SUBJECT: MANAGEMENT REORGANIZATION OF PLANT STAFF

R. E. Ginna Nuclear Power Plant

AMENDMENT TO PROVISIONAL OPERATING LICENSE

Amendment No. 58  
License No. DPR-18

Figure 6.2-2

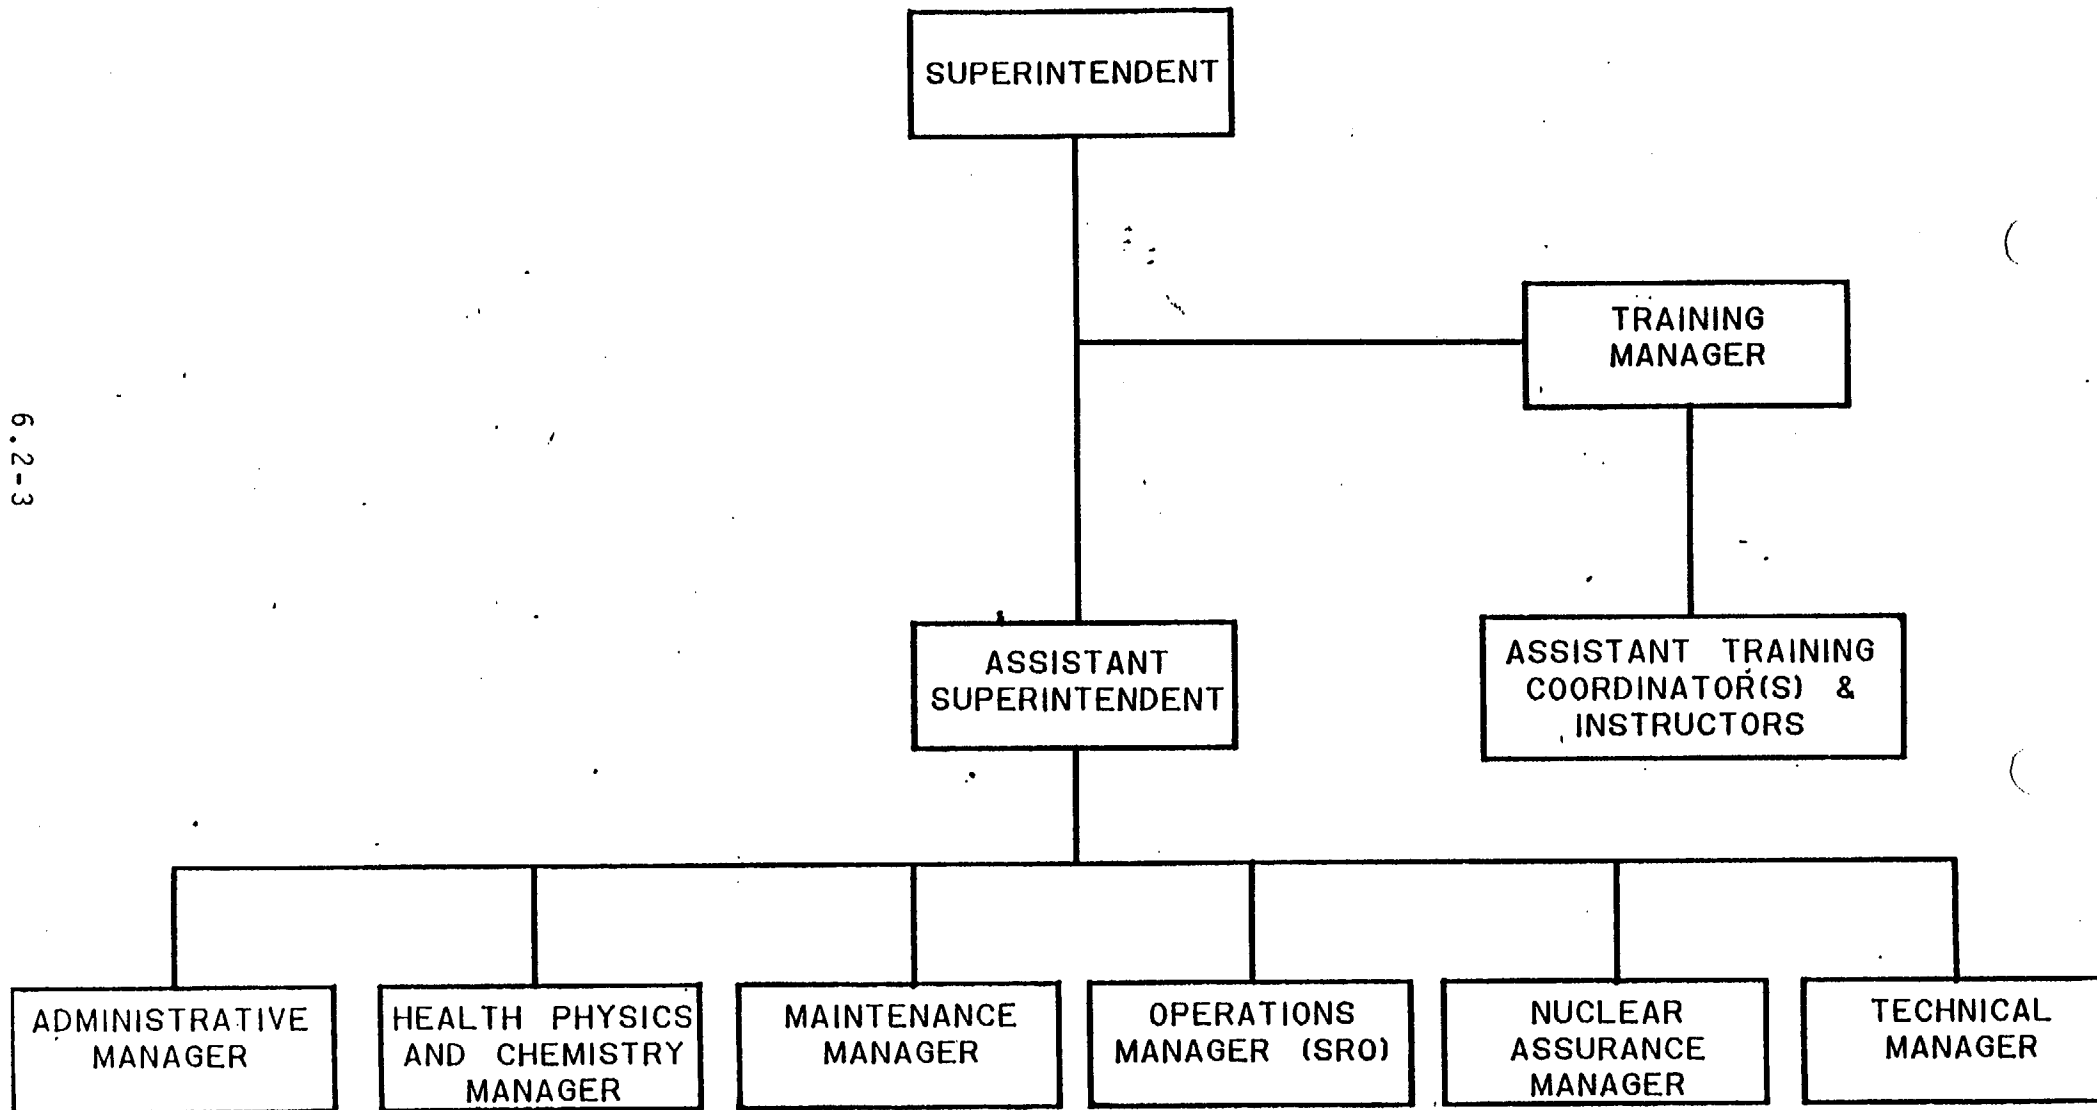
6.2.2 The Facility organization shall be as shown on Figures 6.2-2, 6.2-3, 6.2-4, & 6.2-5 and:

Two of the Sections (Administrative Section and Nuclear Assurance Section) are new. The functions of Cost Control Coordinator, Administrative Computer Systems Analyst, and the function of the Office Supervisor will be reporting to the Administrative Manager.

Reporting to the Nuclear Assurance Manager will be the Operational Assessment Engineer (formerly the Technical Assistant for Operational Assessment), the Quality Control Engineer, and the Fire Protection & Safety Coordinator. Also within this section the function of the Quality Control Inspection Supervisor, reporting to the Quality Control Engineer, will be established to coordinate the inspection activities of quality control on plant and project jobs. The Quality Control engineer will continue to report to the Superintendent regarding station activities affecting quality and that these activities are in accordance with approved drawings, specifications, and procedures. This change will consolidate those staff functions concerned with the assurance of implementing the operational, quality and regulatory requirements of the administrative controls into an independent section. Along with this change, the Nuclear Assurance Manager will become a member of the PORC along with the Quality Control Engineer remaining on the committee.

Figure 6.2.3

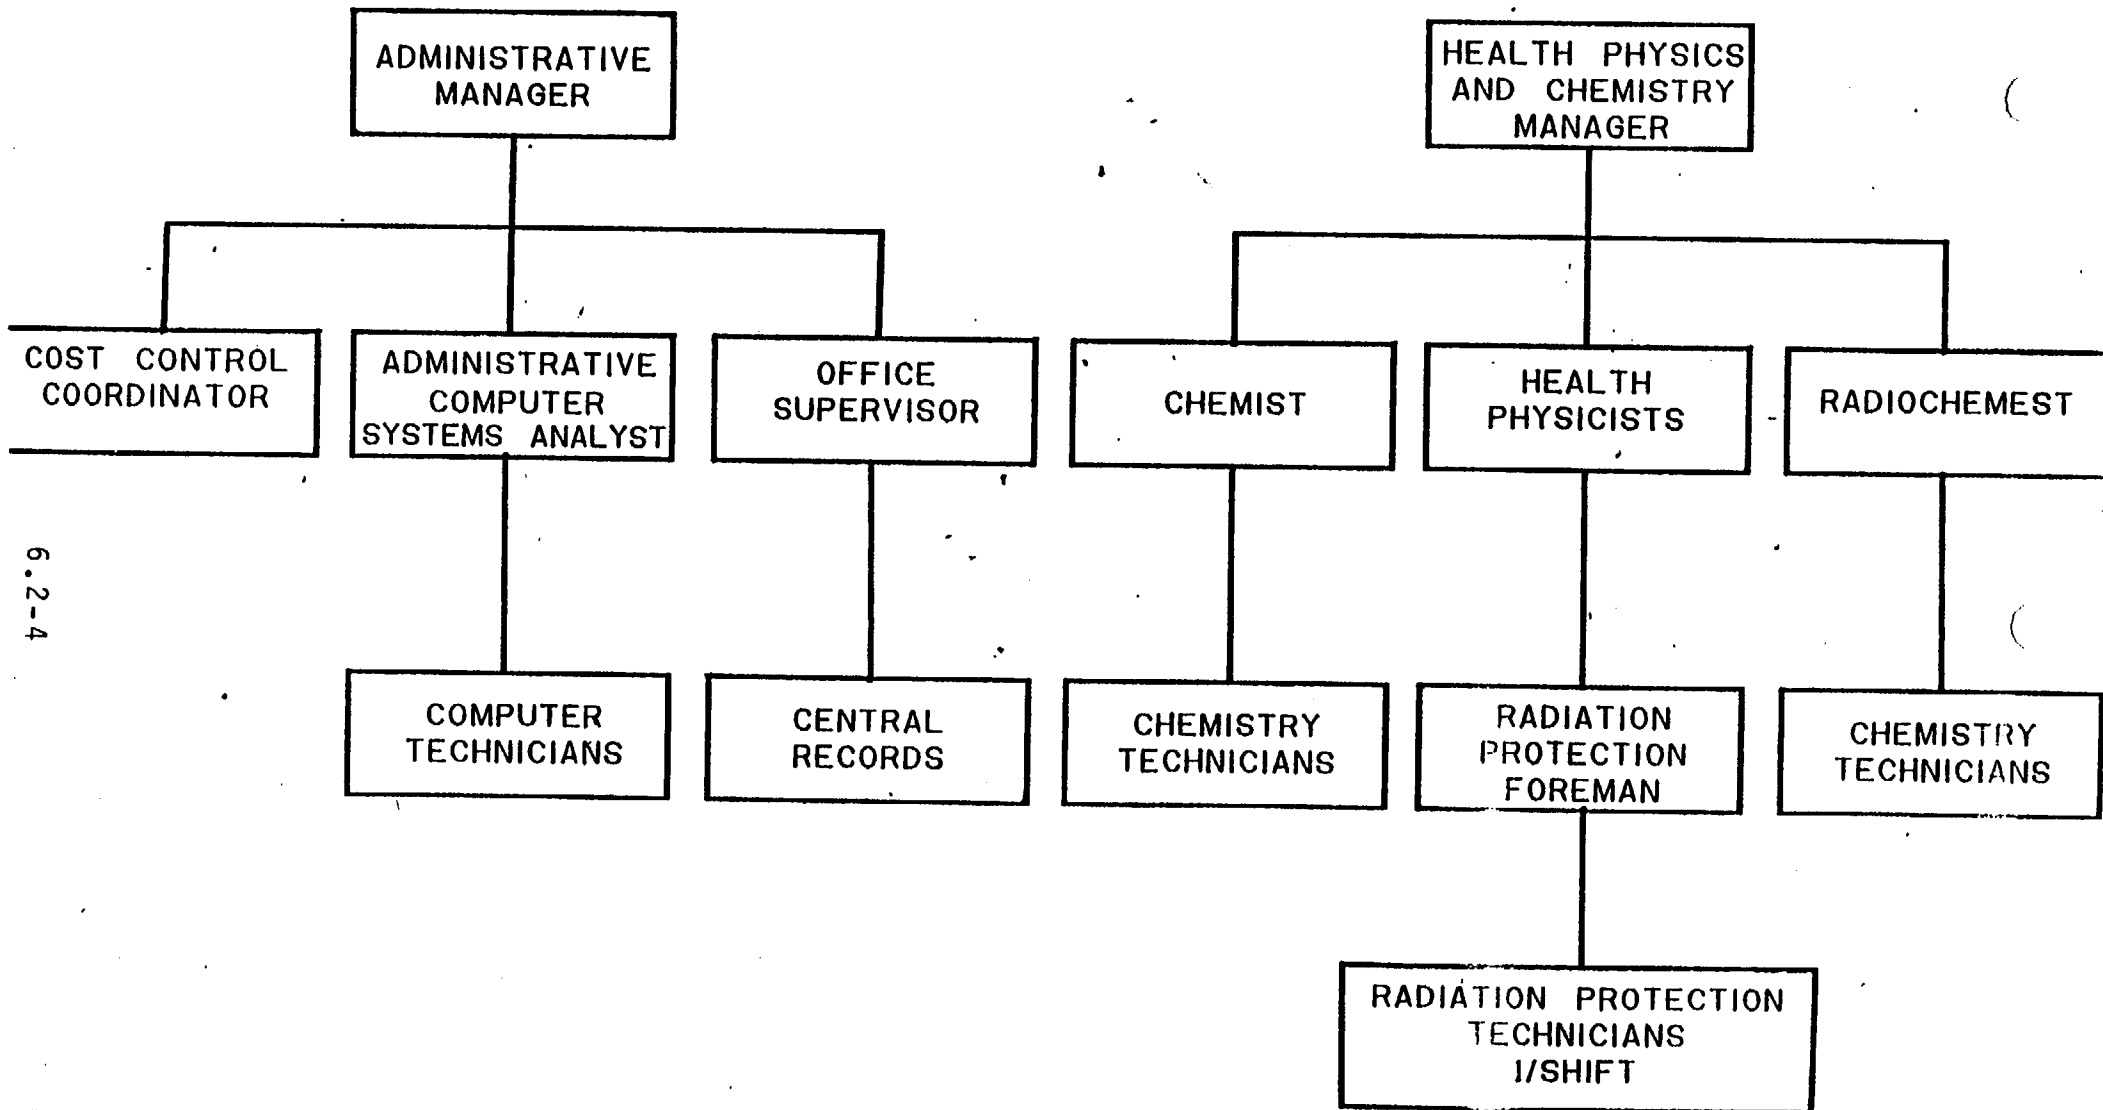
Other changes include the positions of Radiation Protection Foreman and Radiochemist in the Health Physics & Chemistry section, the change in title of the Nuclear Engineer to Reactor Engineer, the addition of the Technical Projects Supervisor and Technical Computer Systems Analyst in the Technical section, and the renaming of the Supervisor of Health and Chemistry to the Health Physics and Chemistry Manager, the Maintenance Engineer to the Maintenance Manager, the Operations Engineer to Operations Manager, the Technical Engineer to Technical Manager, and the Training Coordinator to Training Manager.
